STATEMENT OF RESPONSE TO LRD OPINION

**Proposed Large-scale Residential
Development**

**Lands at Forest Road,
Swords, Co. Dublin**

Applicant: Golden Port Homes Limited

Fig. 3 – Contiguous elevation along Forest Road

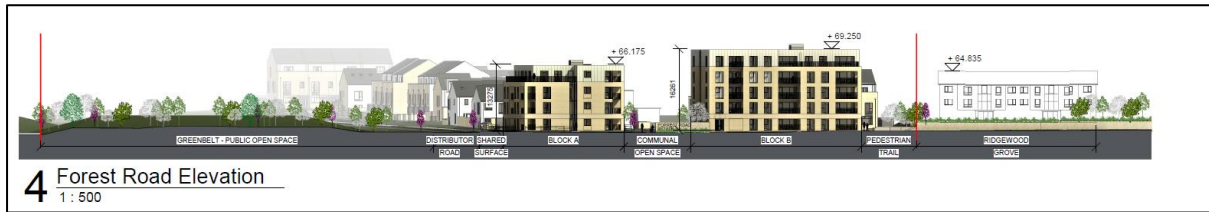
FCC Opinion: *Further consideration is needed regarding the size and visual impact of the proposed five-storey apartment blocks on the eastern part of the site, particularly due to its rural setting next to Green Belt land. Concerns include the building's height, design, roofline, and prominent cantilevered balconies. It's recommended that the applicant reduce the building height or recess upper floors, and reassess its distance from the road to lessen its visual dominance. The building's shape also allows for semi-recessed corner balconies without affecting daylight access.*

Block A was also redesigned and reduced in height from 5 storeys to 4 storeys and the previously proposed cantilevered balconies have been internalised/integrated into the footprint of the block. The height and transition in scale of the scheme is such that it is taller on the northern part of the site, i.e. Block B will be 5 storeys as it adjoins the existing apartments to the north and Block A steps down to

4 storeys as it addresses the less developed area to the south. Block A has also been reorientated so that it now better addresses the access/distributor road to the south.

The roof profile of the apartment blocks is materially different from what was proposed at Pre-Planning Consultation Stage with the upper floor now designed with a different palette of material. The upper floors of the apartment blocks have also been recessed from the building edge, which further reduces the overall bulk and appearance of height of the scheme.

Fig. 6 – VVM7 indicating the proposed acoustic wall facing Forest Road (outlined in red)

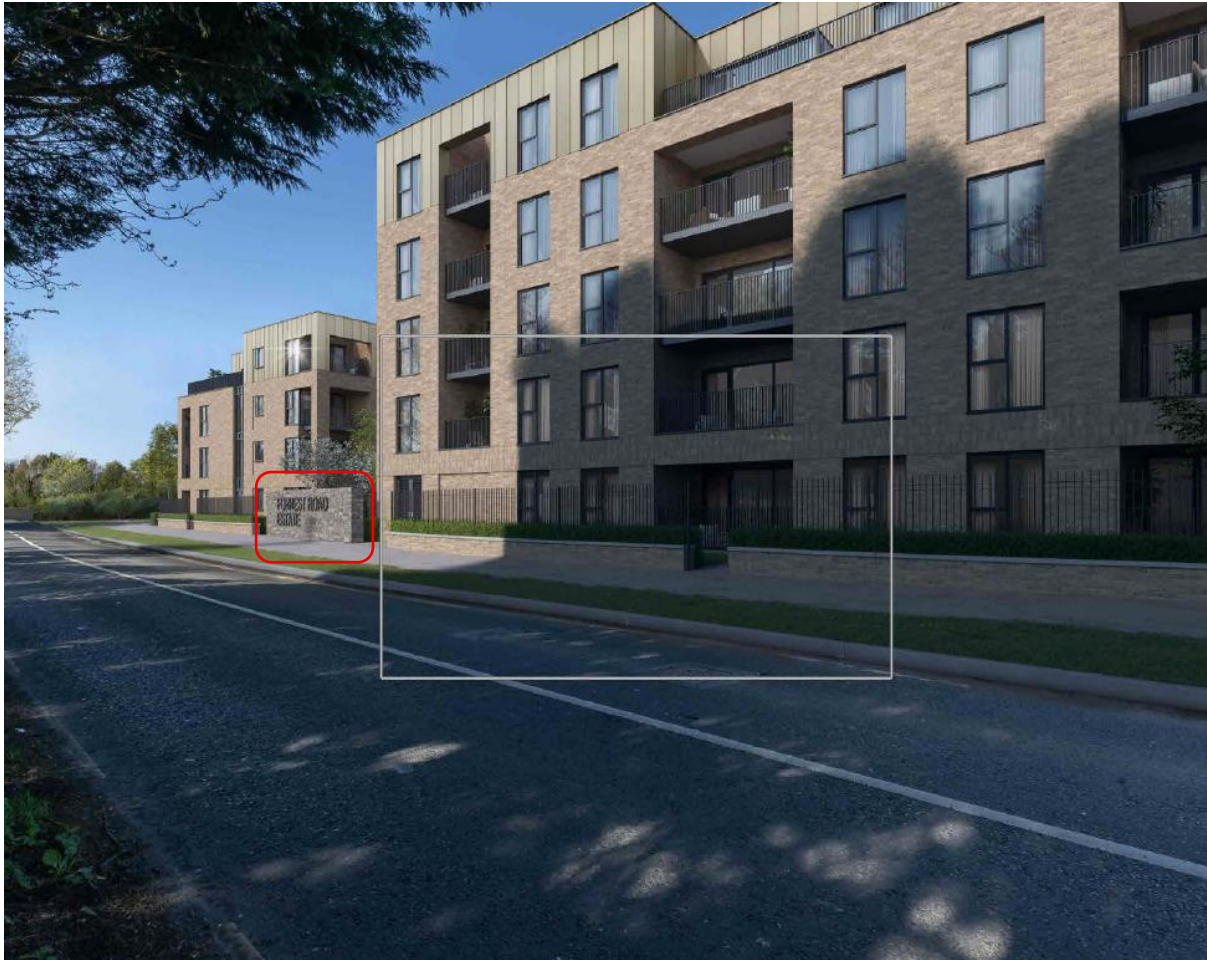
FCC Opinion: Due to the site's location within Dublin Airport Noise Zones B and C, there are concerns about potential noise impacts. The applicant must clarify noise modelling assumptions, provide separate results for aircraft and road noise at multiple heights, and detail sources of night-time noise events. Eastern buildings should be reoriented to shield balconies from road noise. Noise barrier walls are not favoured; however, full details, including location, materials, and visual impact, must be submitted. A Visual Impact Assessment and additional information under LRD regulations are also required.

It was determined that additional design changes were not required to the apartments. However, an acoustic wall is proposed in front of the communal open space between Blocks A and B. This will be a stone wall, 2 metres in height and will be consistent with the existing wall to the front of Ridgewood.

This is captured in VVM7 by 3D Design Bureau, which is extracted below for the convenience of the Planning Authority. It is respectfully considered that this, in fact, acts an attractive piece of boundary treatment for the overall scheme.

Fig. 9 – Connectivity to Ridgewood

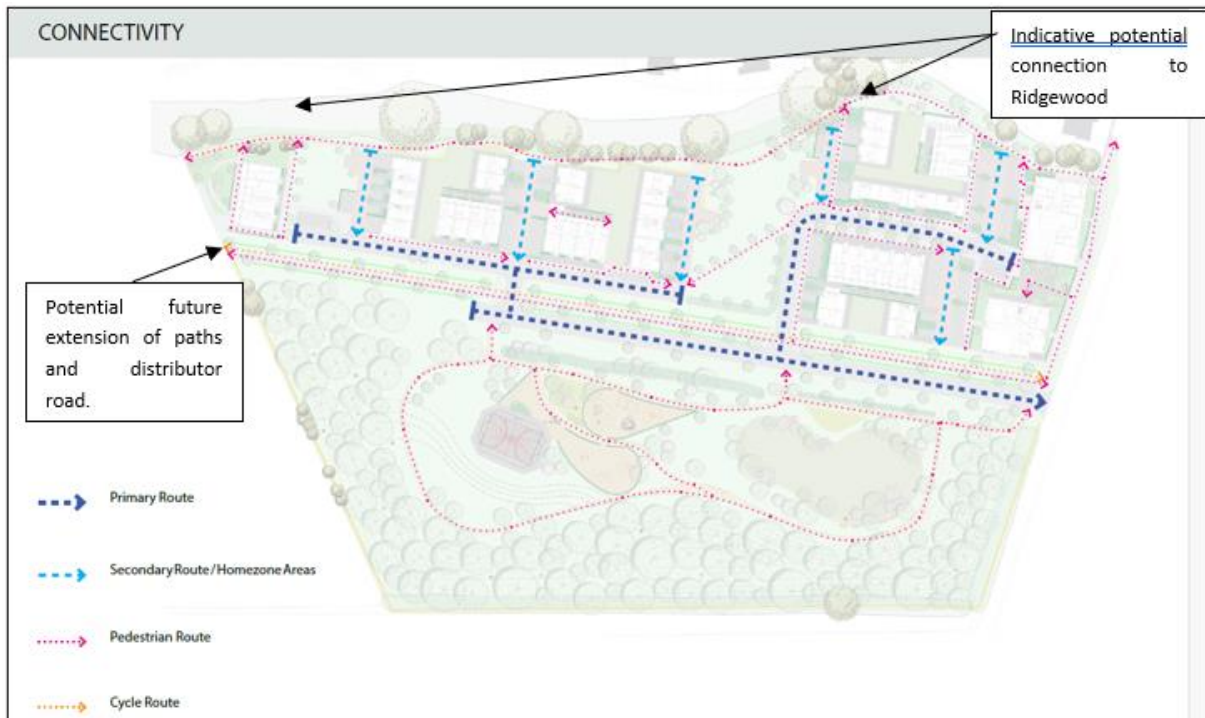
FCC Opinion: Public Open Space: *The proposed pedestrian link between the subject site along the northern boundary into Ridgewood Green needs further consideration. Its current location does not link to existing paths in the adjacent site.*

A new walking trail is included along the northern boundary of the site, designed in a no-dig manner below the tree line, it will offer connectivity along the northern fringe of the site and potentially into Ridgewood to the north. The scheme has been designed such that a connection into Ridgewood could be facilitated between the existing open space in Ridgewood and the proposed Open Space 1 in this development. RMDA have prepared a drawing indicating how this could be provided. Given that Ridgewood is not in the control of the applicant, no works are proposed on the Ridgewood site, but rather the drawing is conceptual.
